**Subject: Change Order No. 5 Water Treatment Plant
Improvements Phase 2 Project**

Re: City of Junction City
Water Treatment Plant Improvements Phase 2
KPWSLF Project Number 3046
HDR Project #10132258 / 10308785
Change Order No. 5 Transmittal

Water Treatment Plant Improvements-
Phase 2

Change Order No. 5

PLAN-SLUDGE LAGOONS

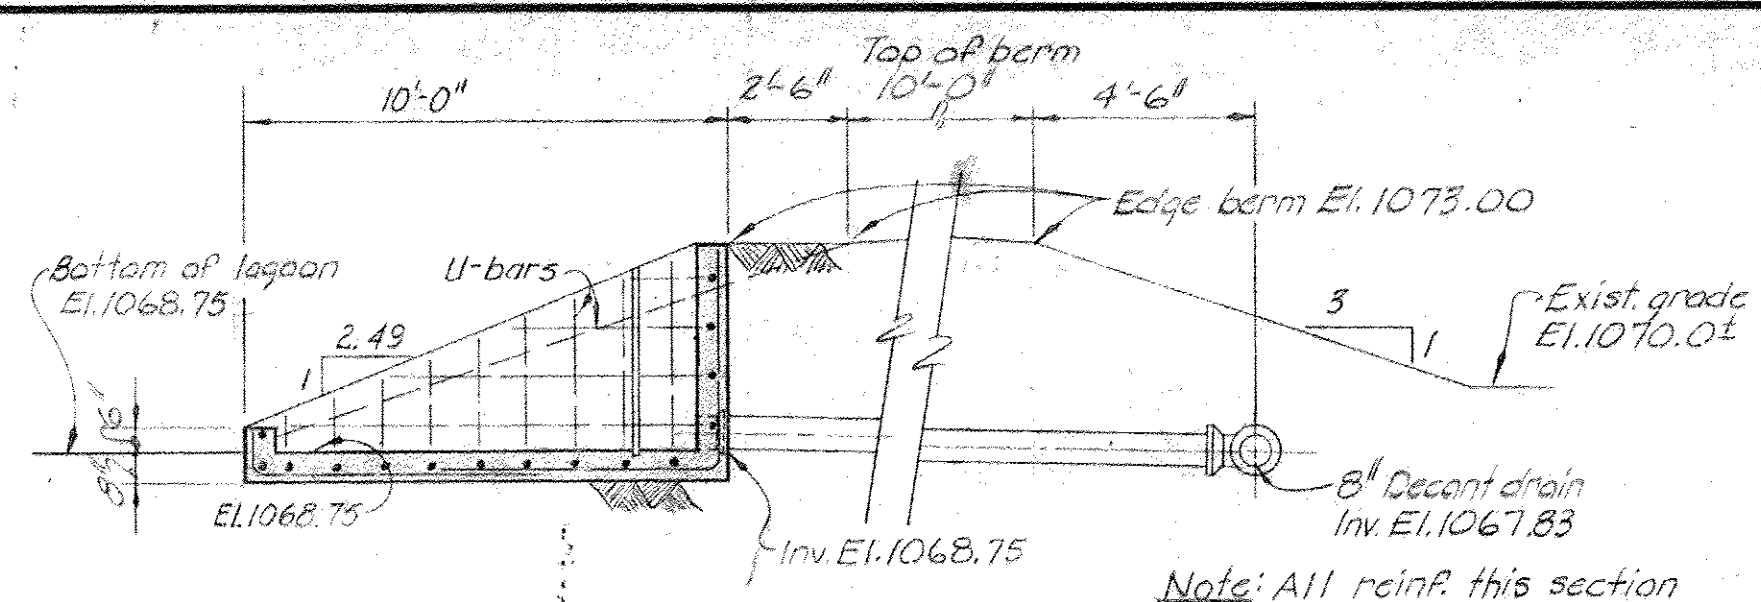
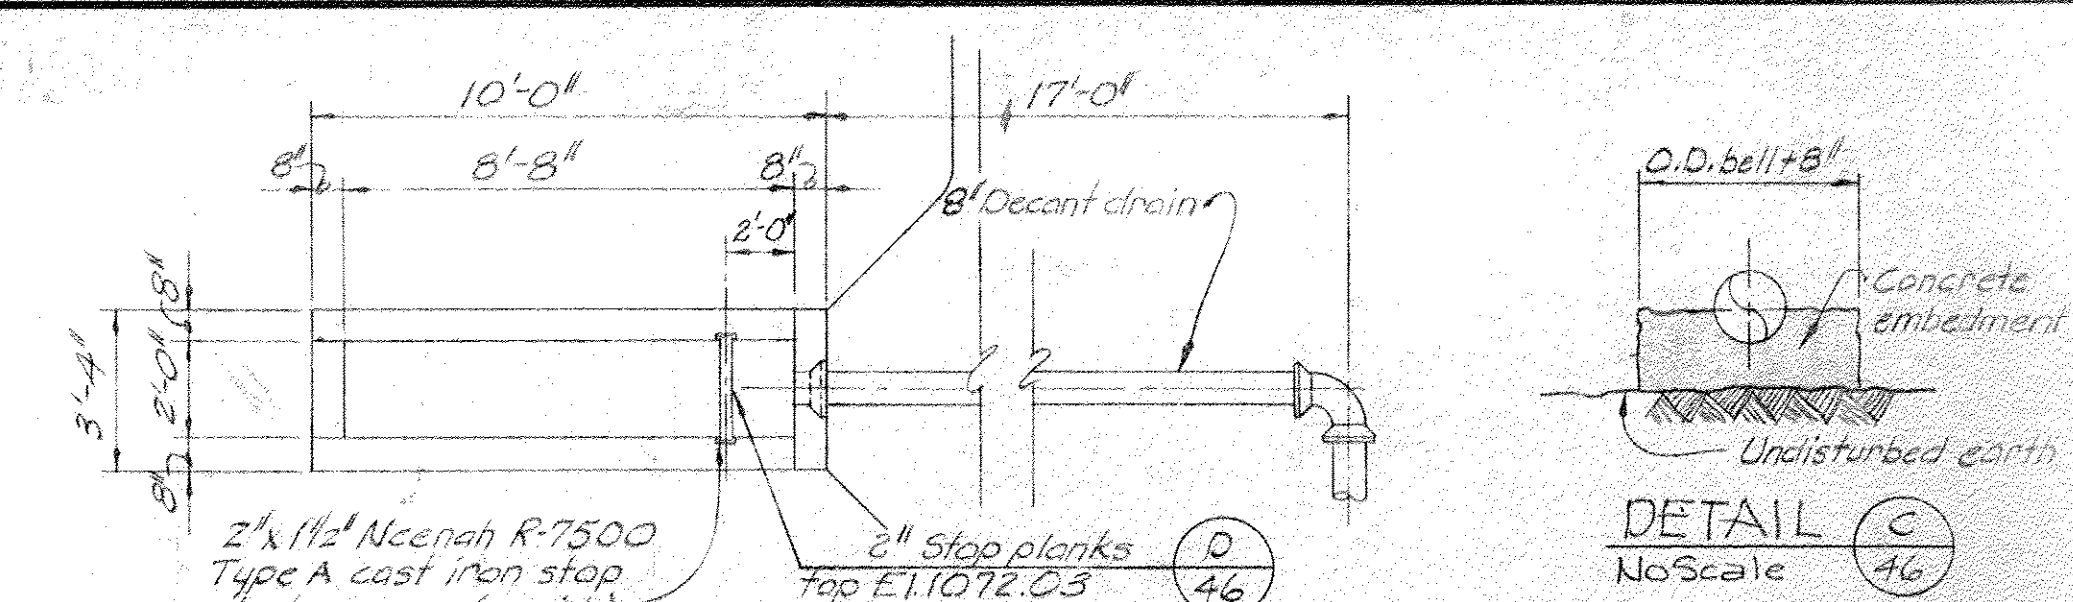
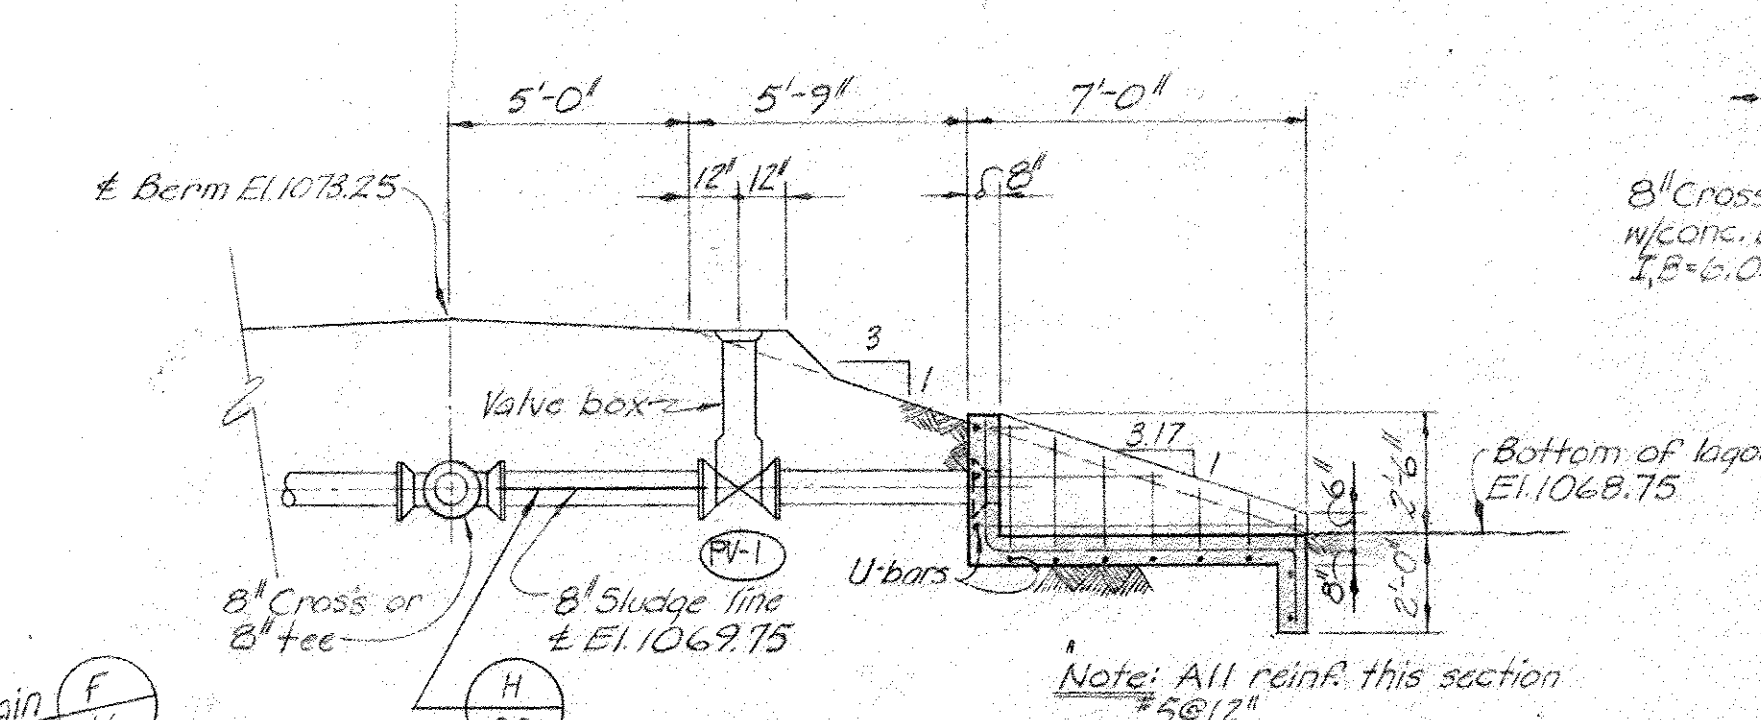
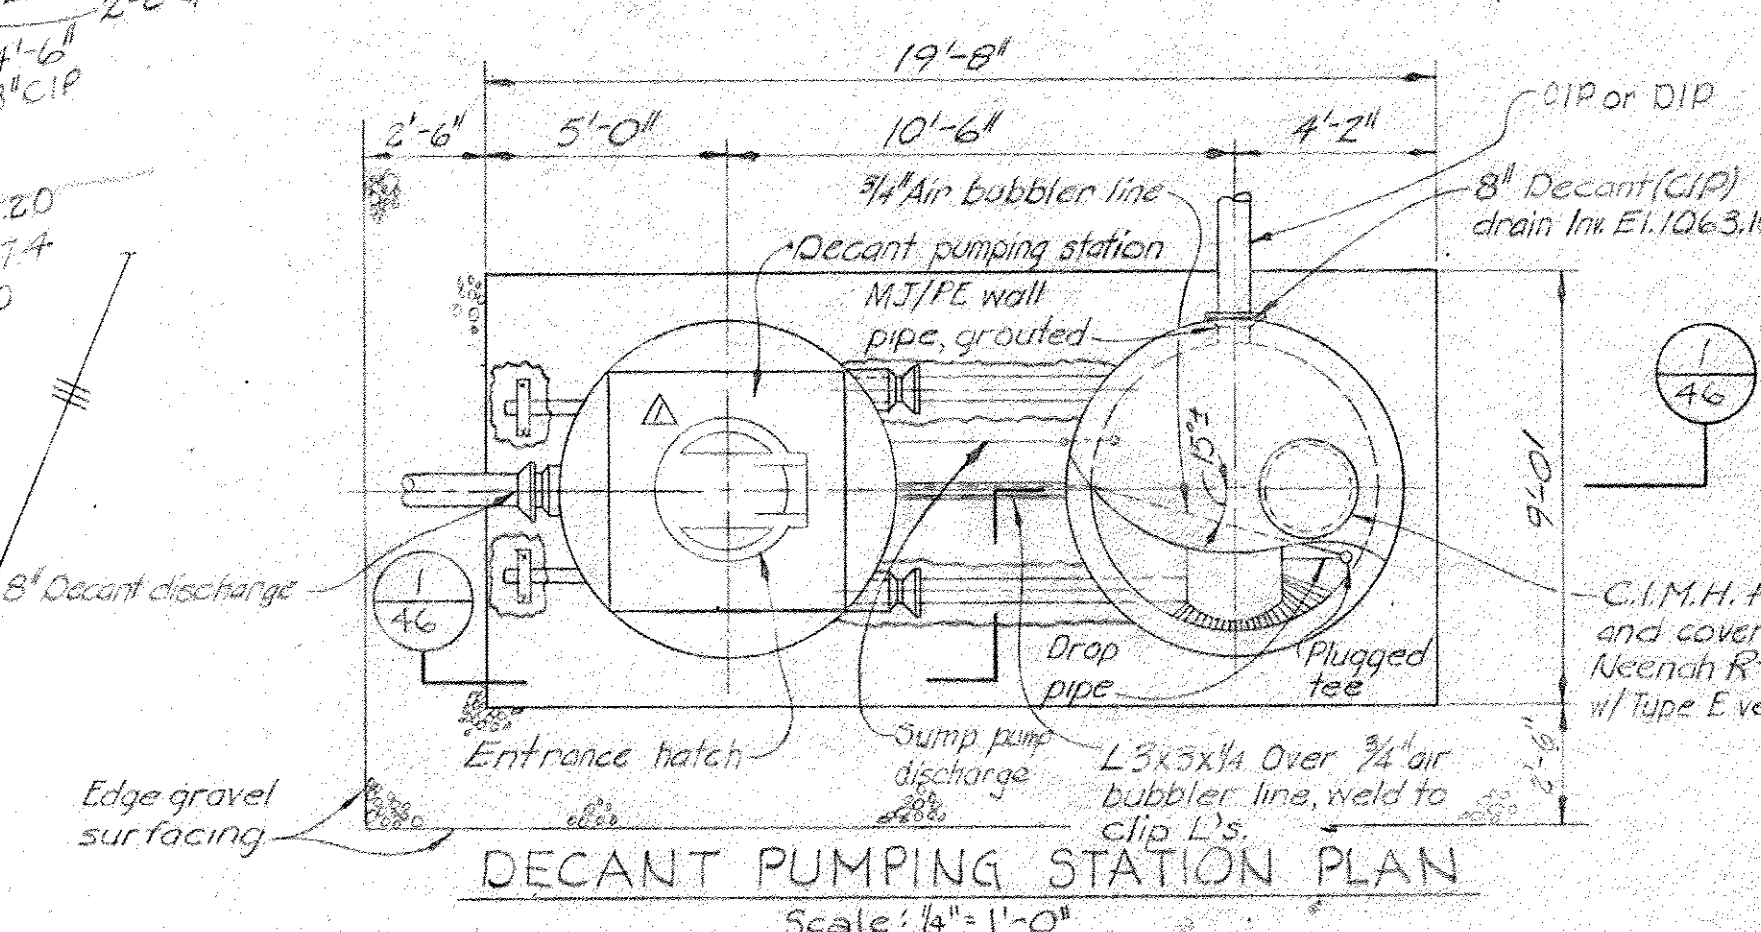
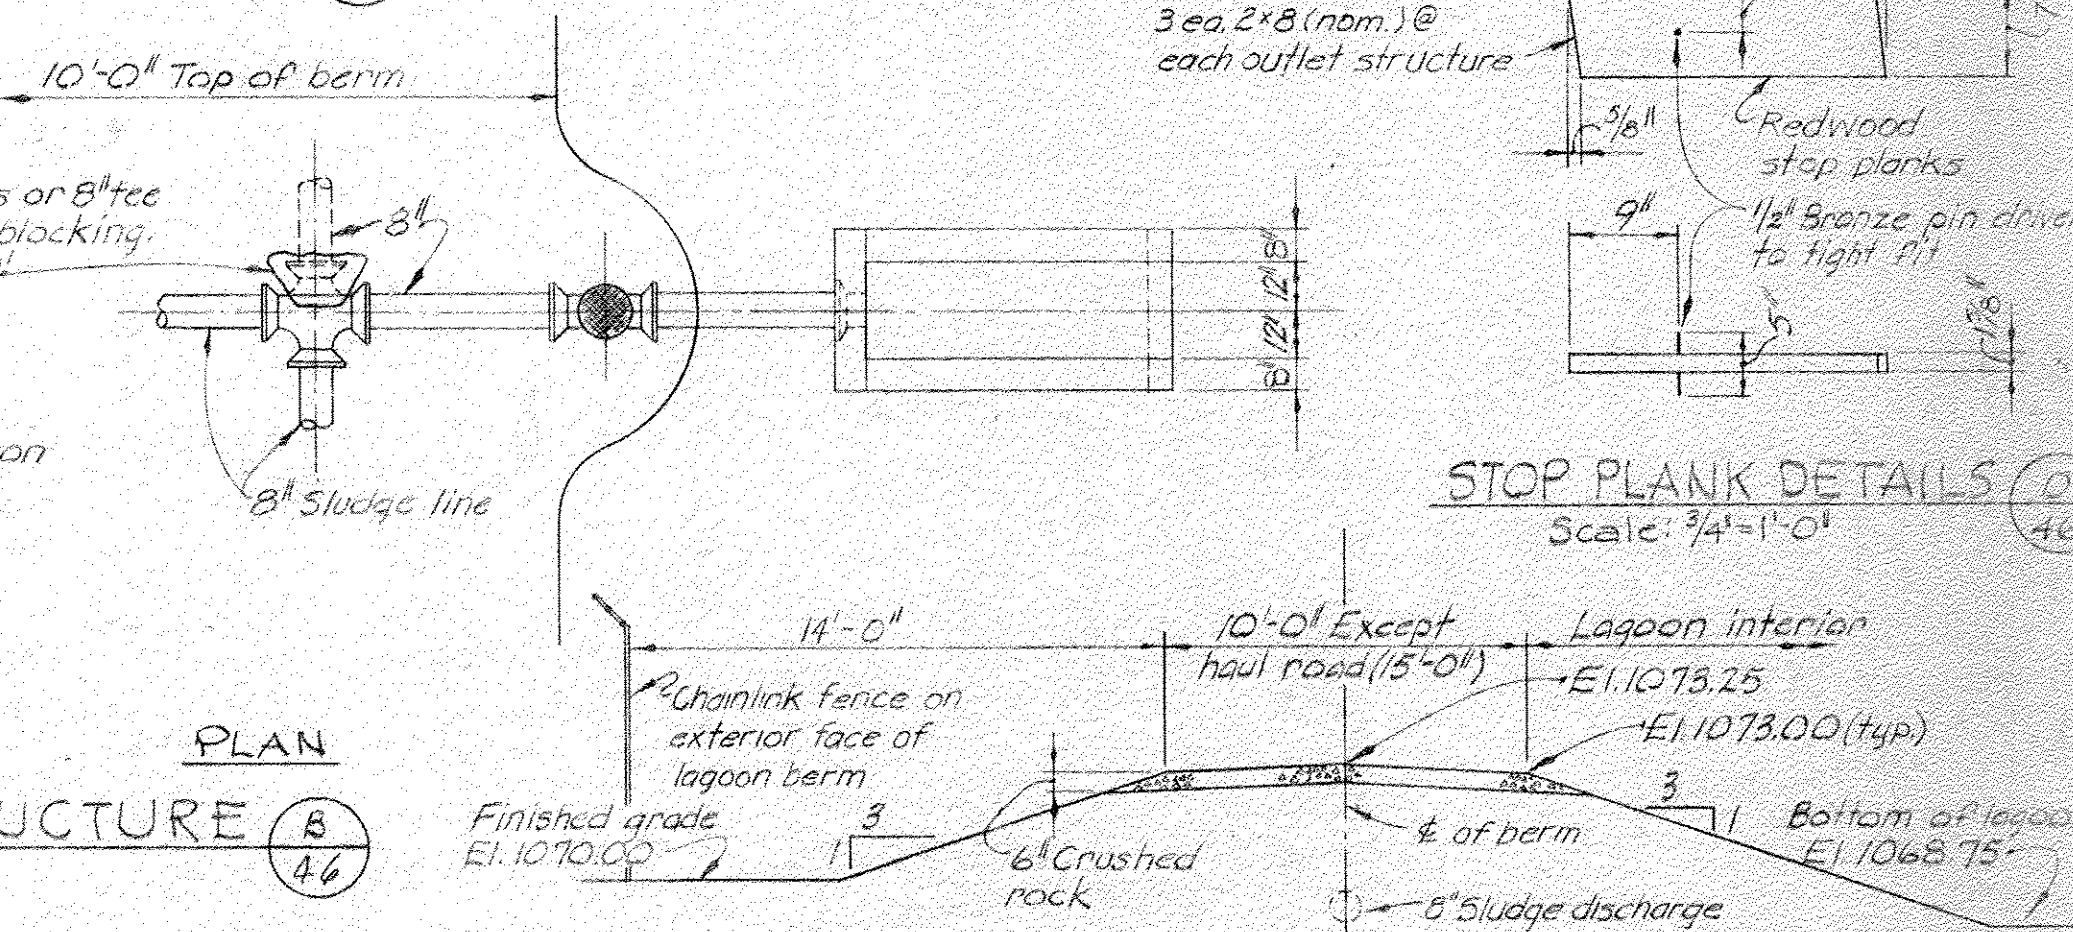
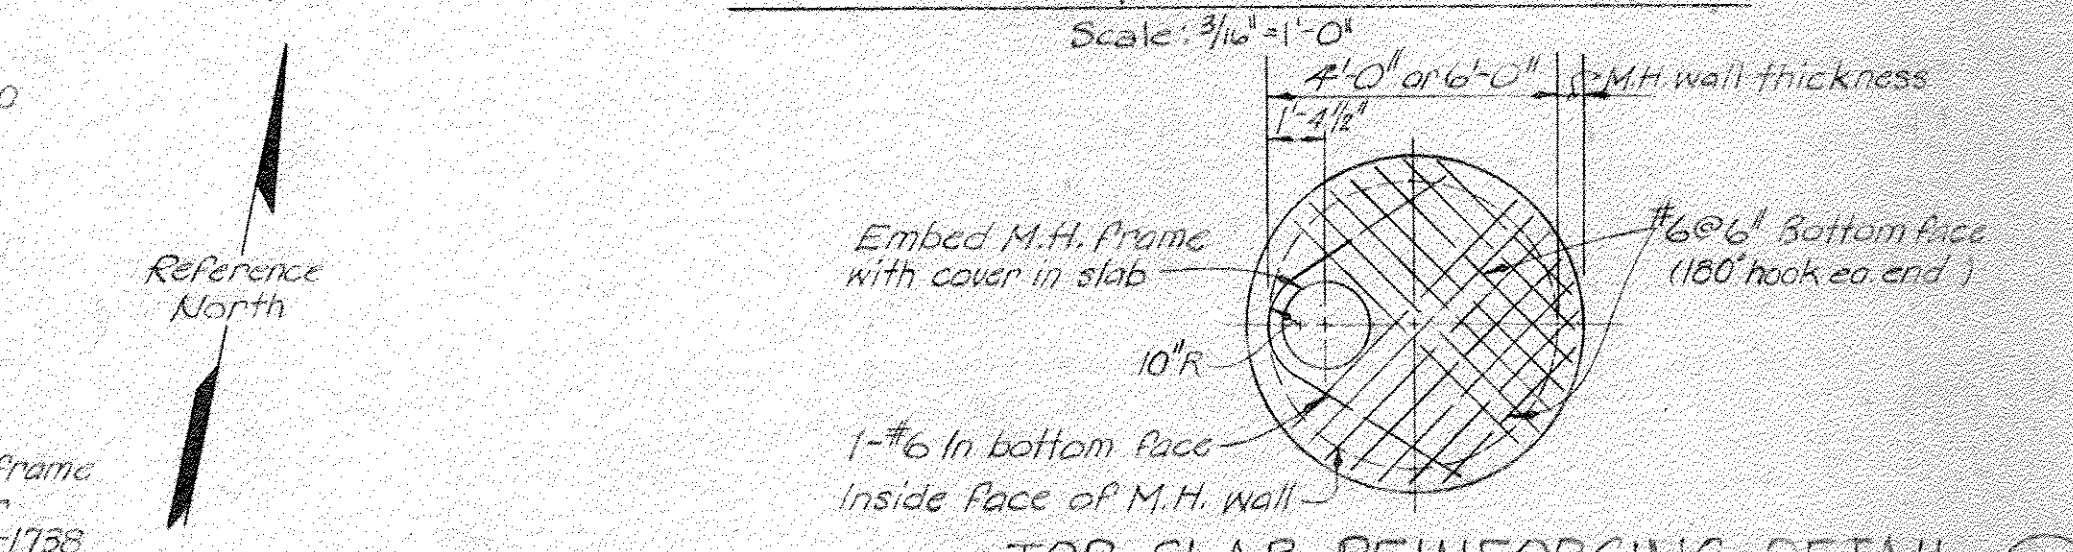
- **Work Change Directive (WCD) #74 – Decant Pump Station Flowable Fill**
This WCD provides for the work required to fill the void below the existing decant pump station with flowable fill. The existing decant pump station was found to be installed directly above a compromised abandoned-in-place metal structure which will be filled to prevent any settlement. The value of this WCD is an increase in Contract Price of \$3,547.00. There is no change in the Contract Time associated with this WCD.
